DOCUMENT 009113 – ADDENDUM No. 1

- A. Project Name: Lowell West Complex
- B. Owner: Albuquerque Public Schools
- C. Owner Project Number: RFP # 19-026 DD – Lowell West Complex
- D. Architect: RMKM Architecture P.C.
- E. Architect Project Number: 01604
- F. Date of Addendum: October 26th, 2018

PROJECT
 ALBUQUERQUE PUBLIC SCHOOLS
 LOWELL WEST COMPLEX

1 WEST COURT STAIR SECTION

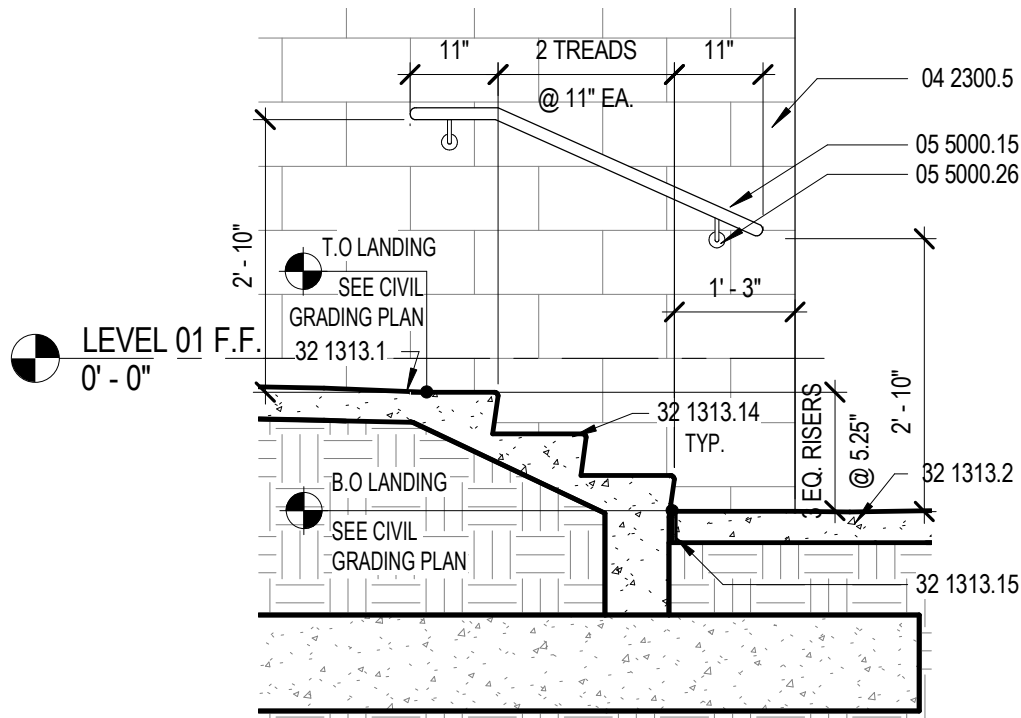
REVISING DETAIL 8/AS-102

NEW SECTION

3 NORTH COFFEE SHOP INT. ELEVATION
 AAD-3 3/16" = 1'-0" REVISING ELEVATION B5 A-414

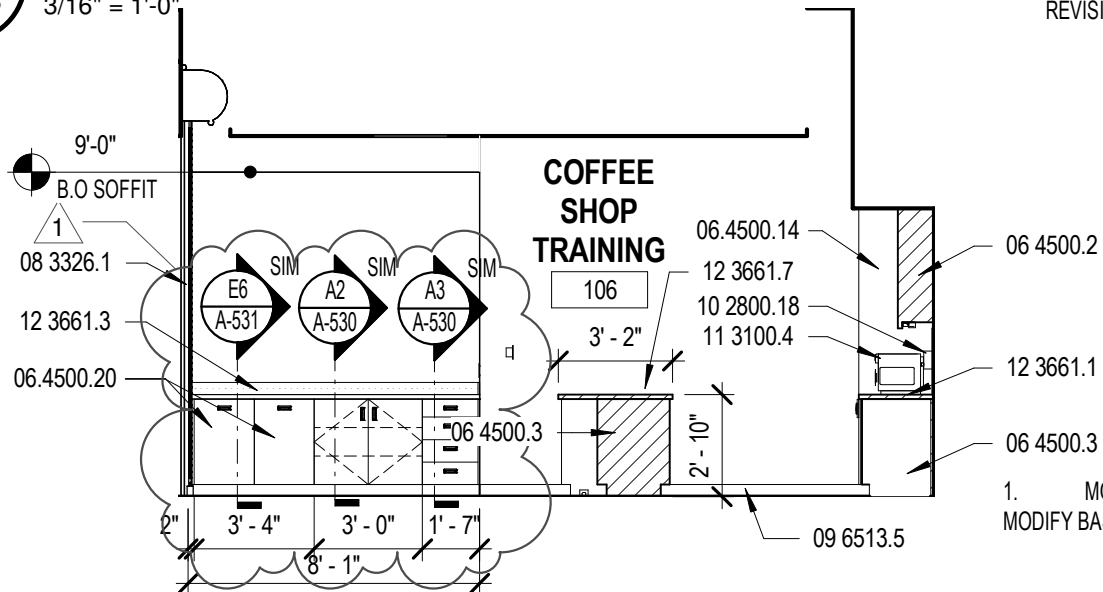
1. MODIFICATIONS TO CASEWORK: REMOVE BASE CABINET AND REPLACE IT WITH AN AREA OPEN BELOW AS SHOWN.

1. MODIFICATIONS TO CASEWORK: MODIFY BASE CABINET UNITS AS SHOWN.
